Access Compliance Report

Public Rights-of-Way

(Pedestrian Signals)

Intersection ID: N/A	Main Street:	Cross Street: N/A	Location: N/A
ADA ID: 0813B1942E78	Signal Type: One Push Button-Non APS	Overall Compliance: No	Severity Score: BTN 1: N/A BTN 2: N/A No BTN: N/A
Codes/Mitigation Info/Possible Solution		Field Measurements/Component Compliance

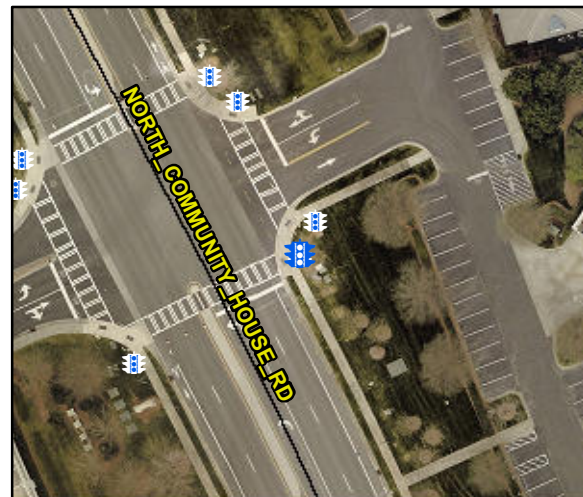
Yes	B 1 Clear Xing Direction?	ClearlyMarked	N/A	B 2 Clear Xing Direction?	N/A
	B 1 Crossing Direction	To SW		B 2 Crossing Direction	N/A
Yes	B 1 DistanceTo XWalk (in)	0.0	N/A	B 2 DistanceTo XWalk (in)	N/A
No	B 1 DistanceTo Curb (in)	106.0	N/A	B 2 DistanceTo Curb (in)	N/A
Yes	B 1 Diameter (in)	2.0	N/A	B 2 Diameter (in)	N/A

Possible Solutions: Replace Signal Push Button With APS Button on New Post. Remove & Relocate Sign.
